Project Outline for Wall Restoration - 435 Arroyo Tenorio

Case #H-95-49. 435 Arroyo Tenorio. Downtown and Eastside Historic District. Lloyd and Tryk Architects, agents for Phillip Coombs, propose demolition; one-story, single family residence with garage. (Tabled by HDRB 3/28/95.)

DATE: April 25, 1995
TO: Historic Design Review Board Members
FROM: Mary Grzeskowiak, Planner III
Joan Cole, Planner II *JG*
VIA: Dennis Thompson, Planning Division Director *DT by mv*

DATE: March 28, 1995
TO: Historic Design Review Board Members
FROM: Mary Grzeskowiak, Planner III
Joan Cole, Planner II *JC*
VIA: Dennis Thompson, Planning Division Director *DT*

SITE PLAN
1/8" = 1'-0"
NORTH

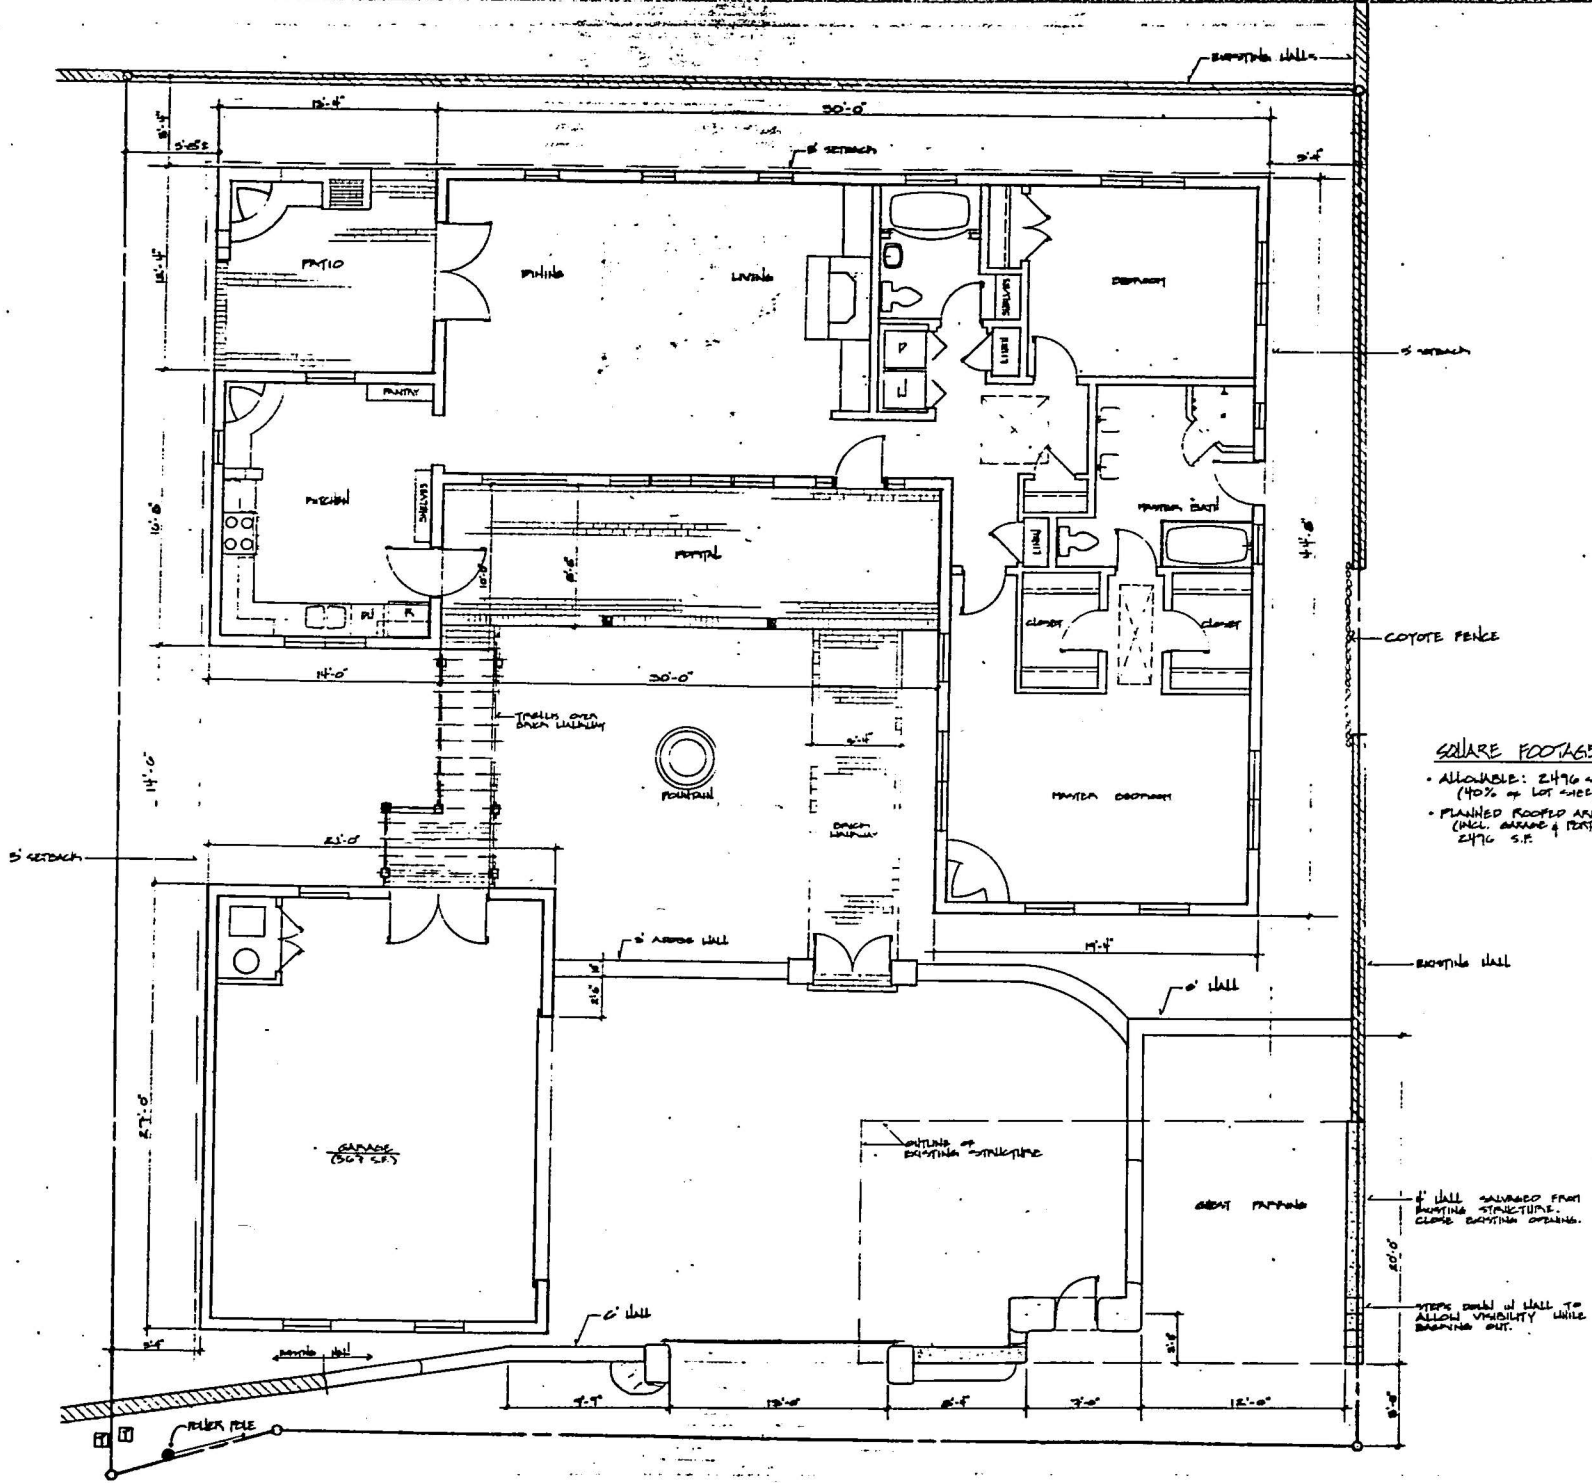
- 1) Section 14-70.13C(2) of SFCC. Prior to application submittal, staff encouraged the applicant to consider incorporating the existing structure in any new plans for the site. The applicant proposes to demolish a structure which sits right along Arroyo Tenorio and is an essential part of this unique streetscape. Because the project proposes to locate the pedestrian gate and guest parking at the location of the existing structure, it does not reestablish this unique existing streetscape.

1 SOUTH ELEVATION 1/4"

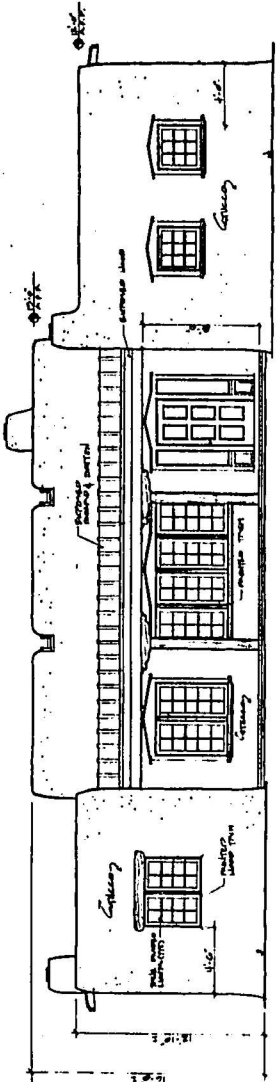
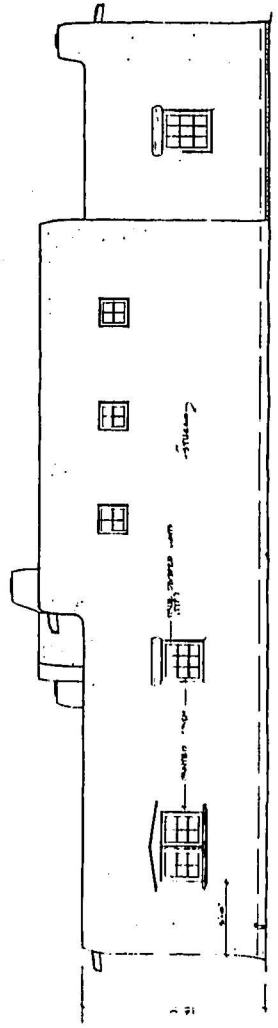
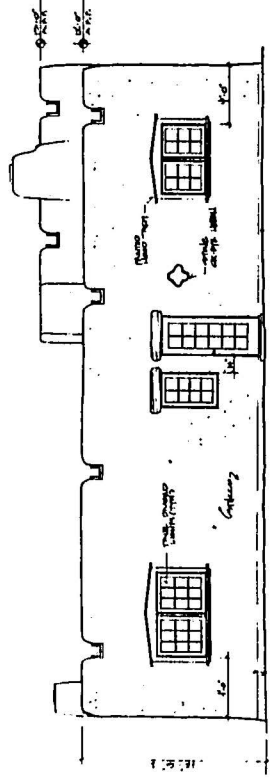
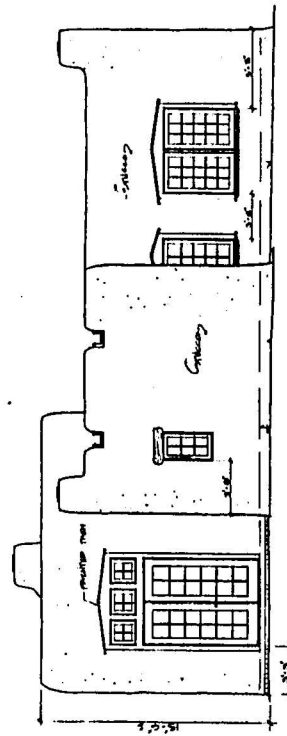
building height of 15'6"-16'0" at the highest point (N and S elevations). The roof is flat with a rounded parapet, canales and skylights. Details include a portal at the S elevation with simple, wood columns and corbels, and a pitched, wood board roof. Windows are multi-lite, TDL wood fixed/casement, some with pedimented territorial style details and others with wood lintels of the pueblo style. A pair of multi-lite French doors are shown at the W facade and a wood, six-panel door with sidelights are at the S elevation.

The garage is 12'0" in height, with a flat roof, rounded parapet, canales, multi-panel garage doors, territorial detailed, multi-lite wood windows with shutters at the S elevation and a pair of French doors at the N facade. A wooden trellis structure covers the brick walkway which connects the portal to the garage. A 3'0" adobe wall is proposed across the S elevation, creating an interior courtyard, while a 6'0" stucco wall separates the property from the street. A 12'0"-13'0" vehicular opening is planned for the center of the S elevation, and a pedestrian gate (10'6" high) and guest parking are proposed for the location of the existing adobe structure.
